RESPONSIVENESS SUMMARY

**RESPONSIVENESS SUMMARY
FOR THE
RECORD OF DECISION
RIVERSIDE INDUSTRIAL PARK SUPERFUND SITE
NEWARK, NEW JERSEY**

Figure 2: PPG paint manufacturing plant in City of Newark, New Jersey (Exhibit 10.B to EPA's September 4, 2020 Statement of Position).

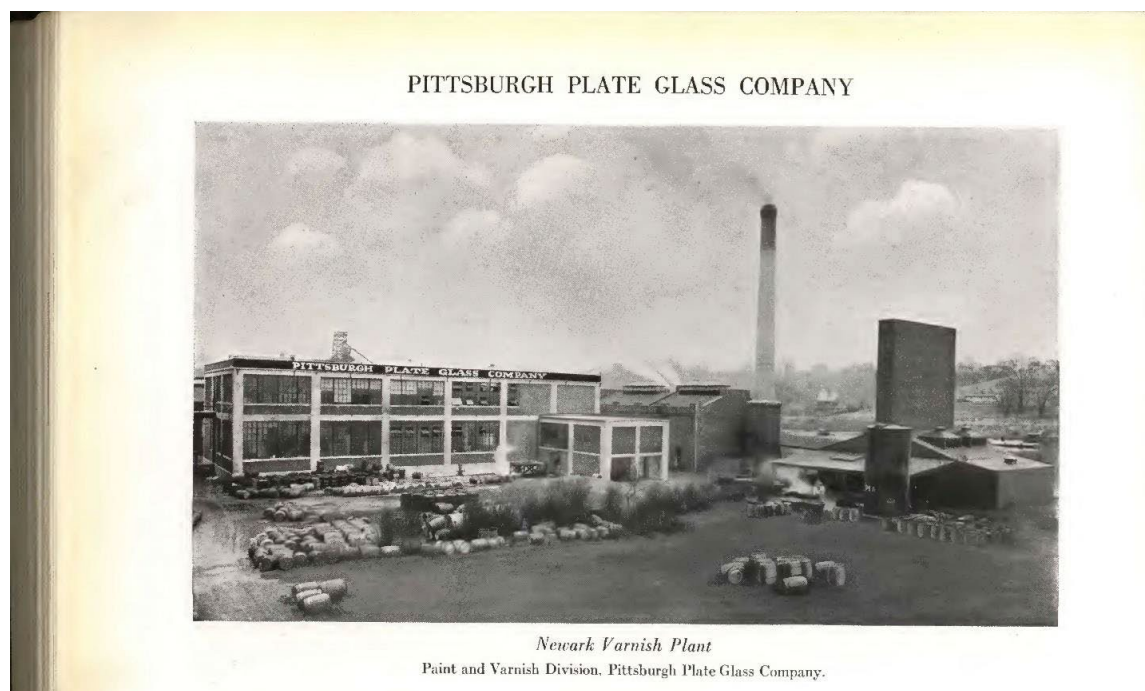
1. Comment: A commenter stated that EPA's Conceptual Site Model (CSM) is flawed. The commenter indicated that the Proposed Plan is based on the assumption of a "top down" CSM, which ignores information presented in the RI. The commenter stated that EPA's CSM does not consider the historic fill as the primary, if not sole, source of lead in groundwater. The commenter stated that EPA's CSM is based on the assumption that historical releases from Site operations contaminated the soil, which in turn migrated to groundwater. The commenter indicated that the impervious surfaces of the Site would have prevented any spills or releases from Site activities from impacting the soil, and any lead that might have reached the soil is likely to be immobile. The commenter also argues that the 'hinged flappers' spaced along the base of the exterior walls in certain buildings were components of standard fire water management systems and were not for the discharge of waste. The commenter believes that historic fill is the source of lead in groundwater, and not the historical spills and/or releases of paint and other materials containing lead that are the basis of EPA's CSM.

A photograph of the Patton facility from the book "Glass, Paints, Varnishes and Brushes, Their History, Manufacture and Use (copyright 1923 Pittsburgh Plate Glass Company)" (Figure 2) depicts Building #9 and Building #6 (looking northeast) on page 24 of its "Paint Section." Building #7A is also shown on the right side of the cited picture; Building #7A would eventually be replaced by the current Building #7. Note that barrels and various materials are stored on the ground in front of the buildings. These buildings border Lot 63/64, where the focused lead removal will occur and Building #7 is on Lot 63. (Note that Lot 63 is one of 15 lots on the Site, and the RI Report includes information regarding Site operations for each lot [RI Report, pages 1-3 through 1-30]).

Figure 3: Lead and Zinc Correlation in Soil/Fill Material from Riverside (Exhibit 13 from EPA's September 4, 2020 Statement of Position)

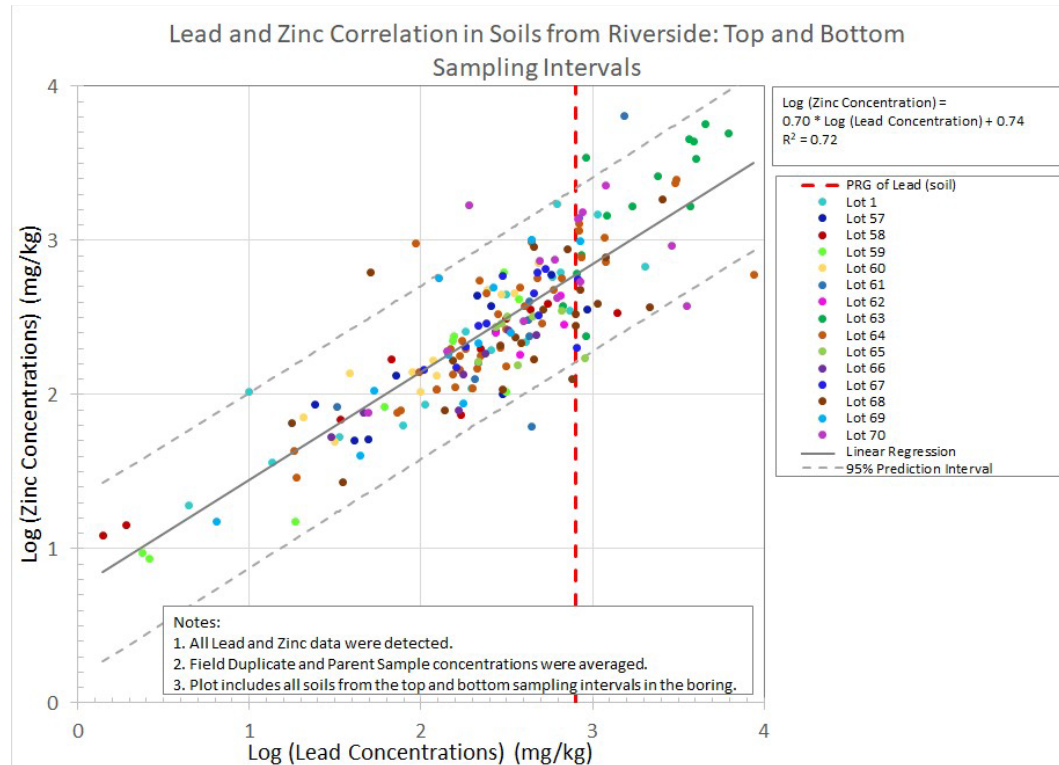
2. Comment: A commenter indicated that if EPA's CSM were accurate and the lead in soil and groundwater at the Site resulted from spills and/or releases from historical facility operations, including paint manufacturing, there would be a correlation between lead and other metals found in paint. The commenter argues that the correlation between lead and zinc does not support EPA's assertion that lead in soil/fill is from historical Site operations.

Response: The historic facility operations support the conclusion that lead and zinc were released into the soil/fill material as a result of paint and varnish plant

housekeeping activities, along with incidental releases of white lead and zinc oxide pigments during material storage, handling, and transfer. The likelihood that PPG operations are a source of lead contamination in Site soil also is supported by a positive correlation between lead and zinc in the soil/fill material samples collected during the RI, with a linear regression coefficient of R^2 of 0.72. The highest levels of lead in the RI borings are reported on Lots 63 and 64 and are correlated with the highest levels of zinc (*see* the cluster of green and light brown points on the right side of Figure 3), strongly suggesting that historical facility operations are a primary source of lead and zinc at these locations.

Figure 4: Figure A-3 from FS Report (July 2020) Appendix A showing delineated areas of lead in soil/fill material that exceed the remediation goal (RG) of 800 mg/kg and the footprint of lead removal around Building #7, which is part of EPA's Preferred Alternative for soil/fill material.

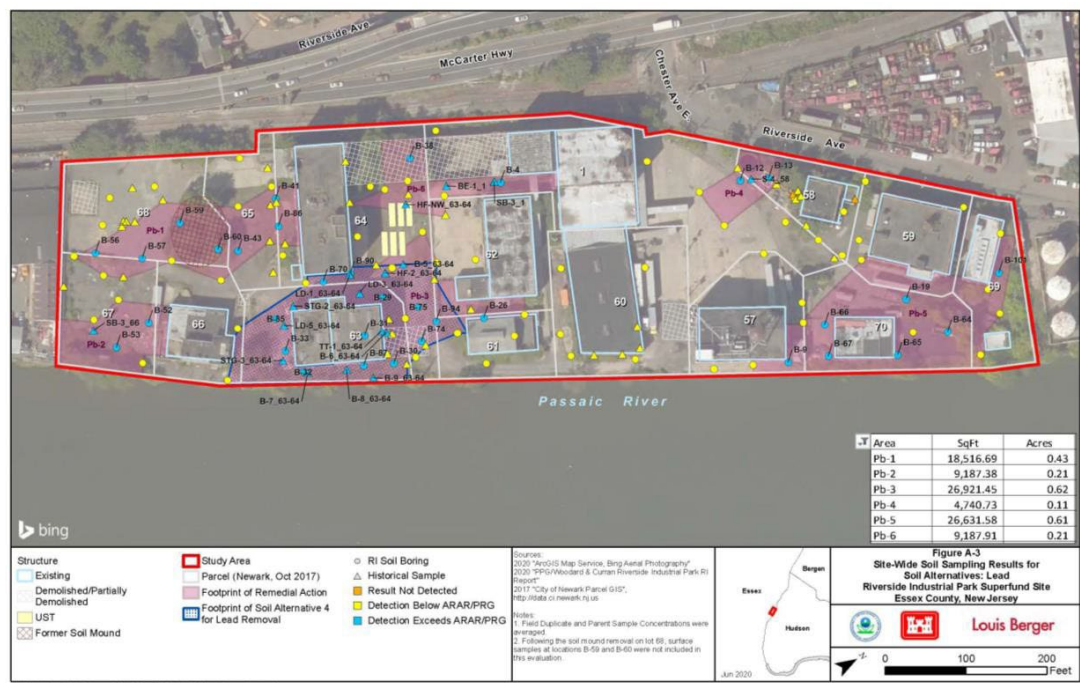
3. Comment: A commenter stated that EPA's CSM is based on lead in soil being the source of lead in groundwater and that for this to be an accurate CSM, the lead in surface soil should correlate to lead in subsurface soil and to lead in groundwater, and the commenter suggests the data do not follow this pattern. The commenter states that the lack of a point-by-point correlation between lead in soil and lead in groundwater undermines EPA's CSM. The commenter also criticized EPA's CSM by presenting an analysis of groundwater data that included grouping the monitoring wells based on locations in the northern portion of the Site, the southern portion of the Site, and the monitoring wells on Lot 63. The commenter concluded from its analysis that the distribution of lead in groundwater is not consistent with EPA's CSM.

Response: The commenter incorrectly asserts that there is no spatial correlation

between lead levels in soil and elevated total lead levels in groundwater. A point-by-point spatial correlation between soil/fill material sample results and groundwater results cannot be undertaken at the Site because of the various groundwater gradients across the Site and lack of co-located samples. Co-located soil/fill material samples and shallow groundwater samples were mainly collected from the temporary well points; however, it was agreed between Region 2 and PPG during the scoping of the remedial investigation field work that these samples would be unvalidated screening samples that would be used only to design the monitoring well network. Consequently, no single soil sample can be used to evaluate the presence or absence of total lead exceedances in a co-located groundwater sample. Instead of using a point-by-point analysis, EPA determined that the cluster of soil/fill material exceedances around Building #7 represents the result of lead contamination related to historical PPG activities in that portion of the Site, and the consistent exceedances of total lead in groundwater samples collected from around Building #7 are consistent with the presence of a Site-related source of lead in soils (*see* Figure 4). Other clusters of soil exceedances are observed across the Site, particularly on Lot 70.
